REQUEST FOR INFORMATION NOT ADDRESSED IN THIS CCO REMAIN IN FORCE					
(1)	03/04/08	BARRIER MODIFICATIONS	JS BM	RG SE	44
MARK	DATE	DESCRIPTIONS	BY	CH'D	CCO#
REVISIONS

CONTRACT CHANGE ORDER NO. _____
SHEET _____ OF _____

DETAILS
SAS SUPERSTRUCTURE ROADWAY EASTBOUND PANEL UP-208 SCHEDULE
NO SCALE

E-154

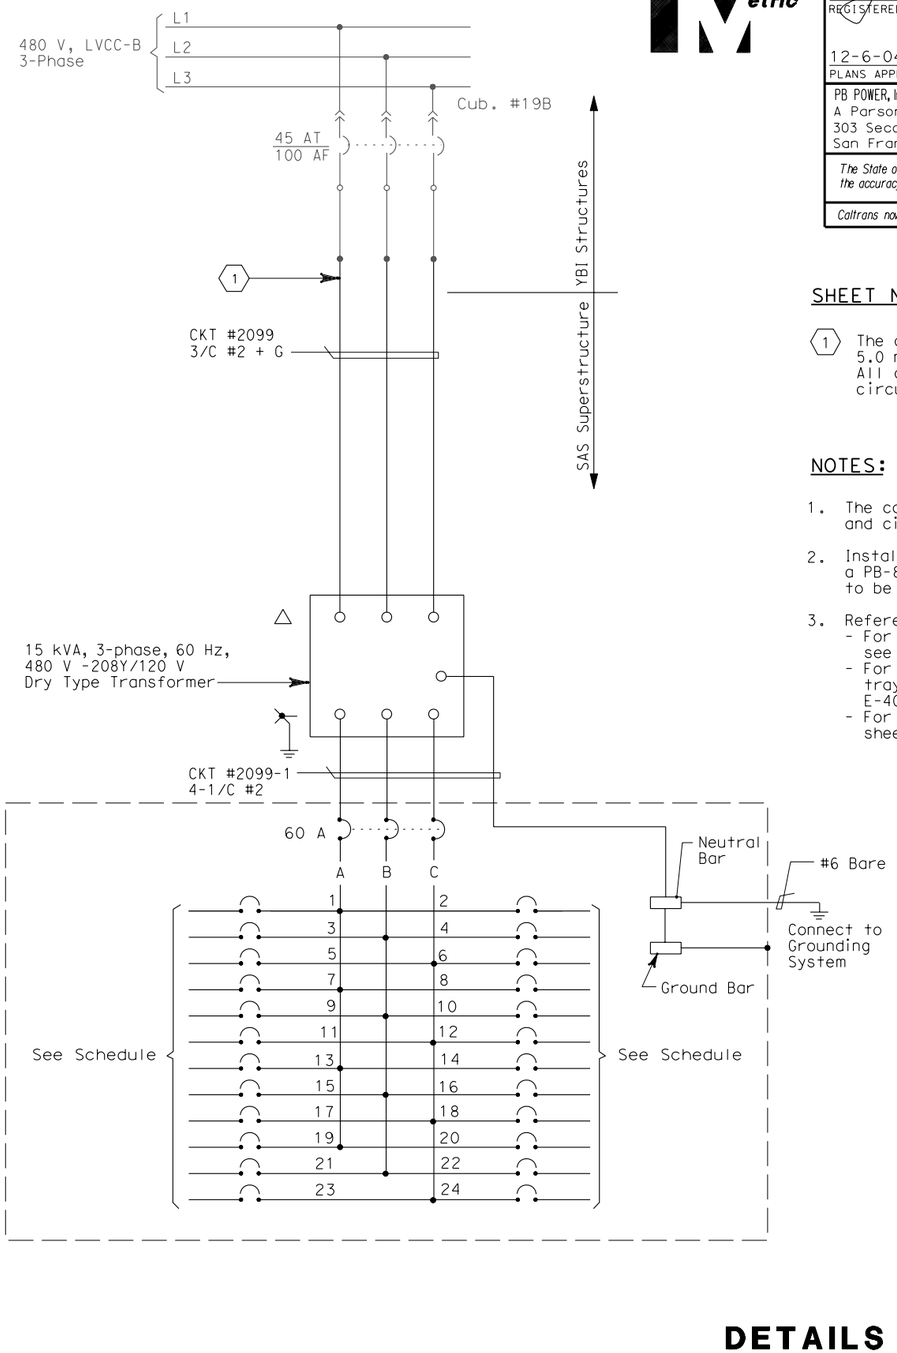
LOAD DESCRIPTION	LTG	REC	OTH.	CB		CB	LTG	REC	OTH.	LOAD DESCRIPTION
Recept (3) Eastbound North Barrier		540		20/1	1 A 2	20/1		(1)	10	CB-243A (1)
Spare				20/1	3 B 4	20/1			10	CB-243B
Recept (2) Service Platform #8		360		20/1	5 C 6	20/1			20	CB-243C,CB-244C
Recept (3) Girder		540		20/1	7 A 8	20/1	984			Girder Lighting (24)
RTU-#11E (PLC Power Supply)			100	20/1	9 B 10	20/1	697			Girder Lighting (17)
RTU-#11E (Lighting & Receptacle)	105	180	150	20/1	11 C 12	20/1				Spare
Spare				20/1	13 A 14	20/1				Spare
Navigation Relay Cabinet # NAP-8			600	20/1	15 B 16	20/1				Spare
Spare				20/1	17 C 18	20/1				
				20/1	19 A 20	20/1				
				20/1	21 B 22	20/1				
				20/1	23 C 24	20/1			(1)	
TOTAL VA	105	1620	850				1681		40	TOTAL VA

(1) The contractor shall extend and coil 5.0 meters of cable in manhole 25 All cables shall be tagged with circuit numbers as shown.
